1.1 Upper Ground Floor - Goods Lift Opening - Revision to Listed Building Consented Proposal

1.2 Upper Ground Floor Level - Goods Lift - Revise Lift Opening Proposal

1. Original Upper Ground Floor Plan - Showing the original lift openings to the lobby

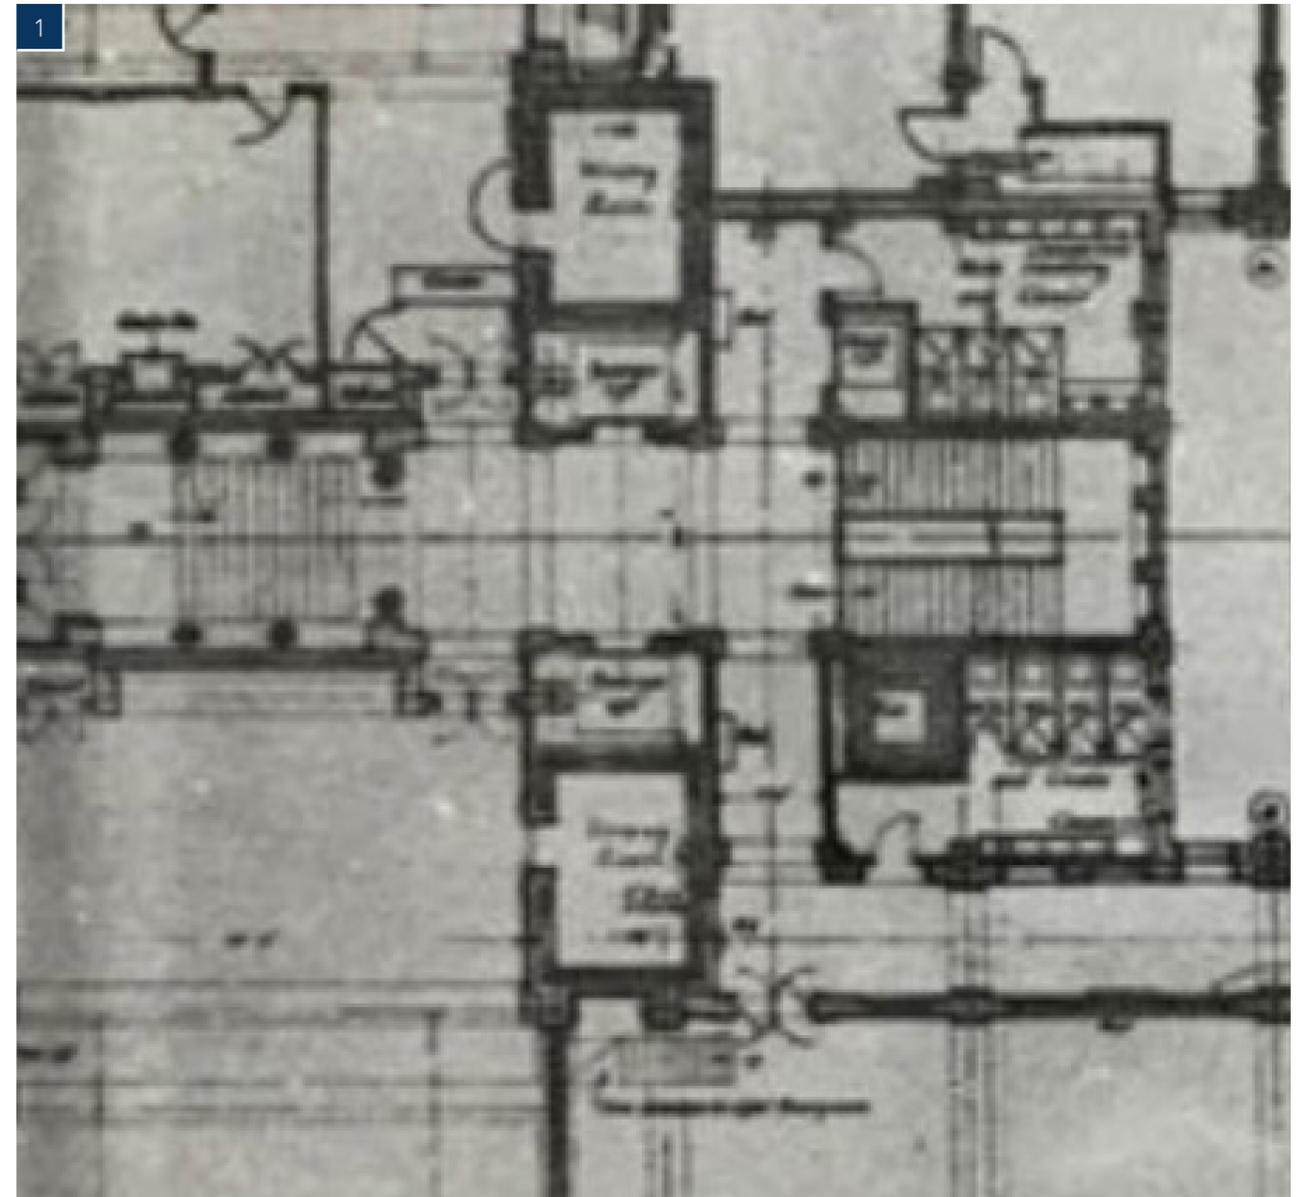
The original building had two lift landings to east and west lifts at this level, when the lifts were upgraded the access to this level was changed with the decision at the time not to have access from Goods Lift 2 to this level. The original aperture was filled in with stone cladding to match the surroundings.

It is still proposed to re-open this access to the current goods lift 2. However during the current works we have been able to survey the internal shaft of the lift and the shaft does not align with proposed opening as previously envisioned.

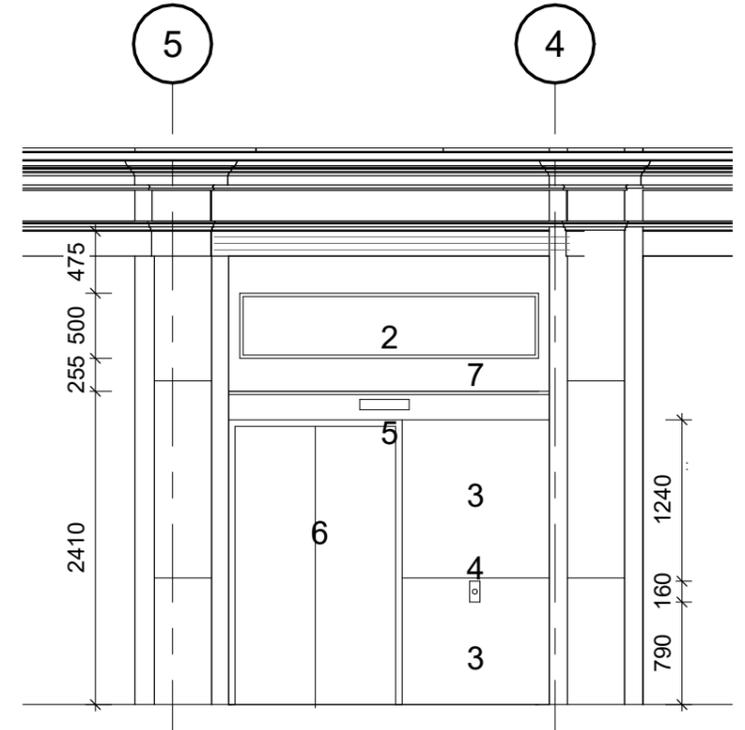
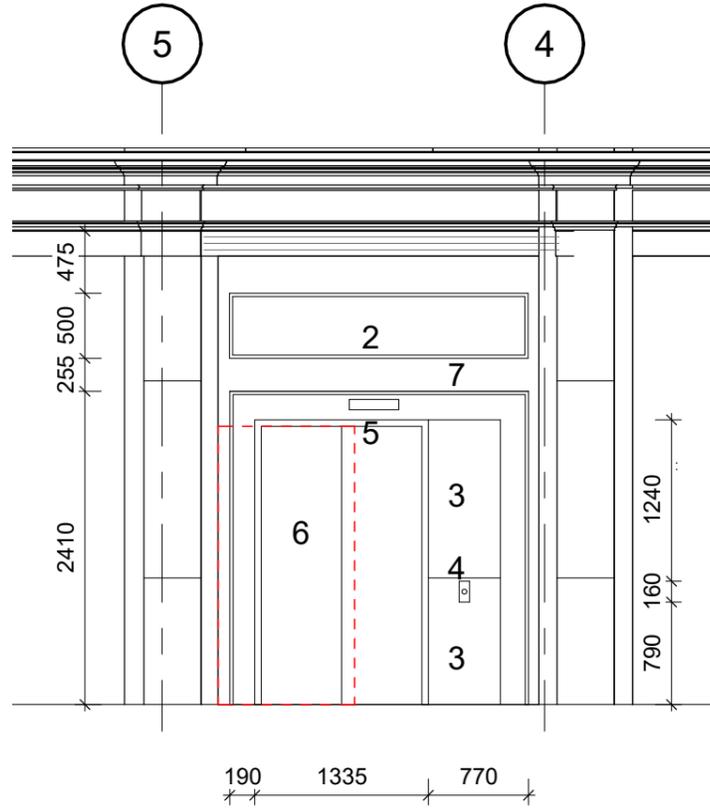
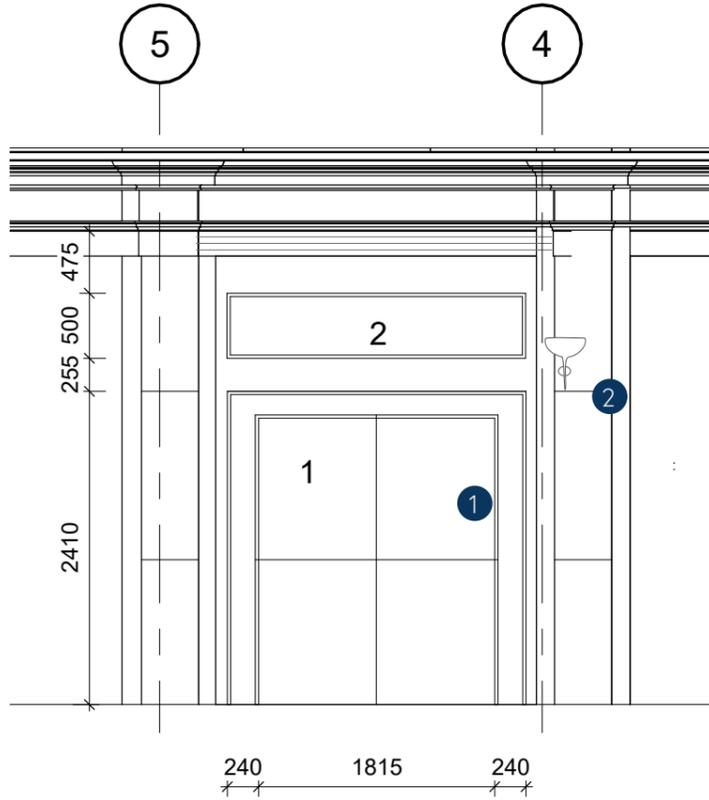
We are therefore requesting an amendment to the opening up strategy / elevation of this area to allow the new lift doors and opening to align with the internal arrangement of the shaft. Without this amendment the proposed opening will not function.

Red line indicates the location of the existing lift shaft & required location of new doors.

We have followed the principles established by the consented scheme and finishes will be upgraded to the quality of the spaces within other refurbished parts of the building. New stone panels will be installed to match the existing panels - it will also be investigated if the existing panels can be reused and relocated.

The upper panels that will need to be temporarily removed to facilitate the opening up works will be carefully removed and then reinstated once the opening up works are complete.

The stone urns that are located by the proposed opening will be relocated within this space and reused.

- Key
- 1 - Existing Stone Cladding to be removed to create a new opening.
 - 2 - Existing Light fitting retained in this location.
 - 3 - Reconstituted panels to match existing and installed in these locations, it will be investigated if the existing panels can be reused.
 - 4 - New lift call button
 - 5 - New lift landing display
 - 6 - New goods lift door frame (in simulated brushed bronze finish to match existing on other floors).
 - 7 - Existing stone panels and lintel to remain. These will need to be carefully removed during lift opening works and re-installed.

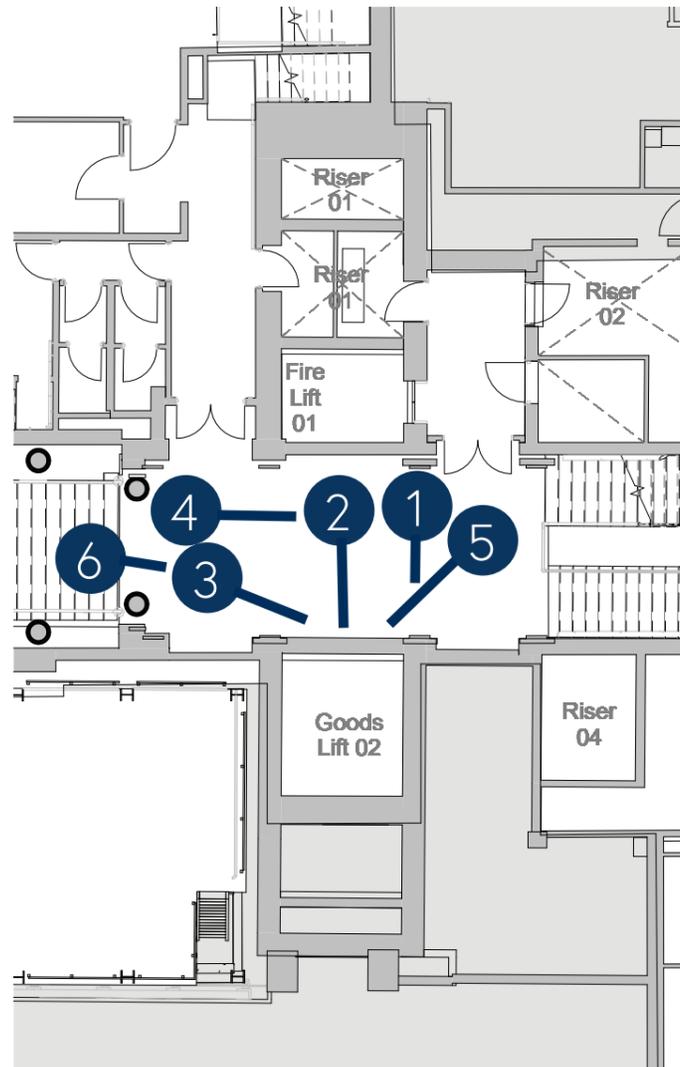
1. Existing Upper Ground Floor - Signage
2. Existing Upper Ground Floor
3. Existing Upper Ground Floor
4. Existing Upper Ground Floor - Showing existing stone infills either side of lobby
5. Existing Upper Ground Floor
6. Existing Upper Ground Floor
7. Red Dashed line indicated location of proposed new opening
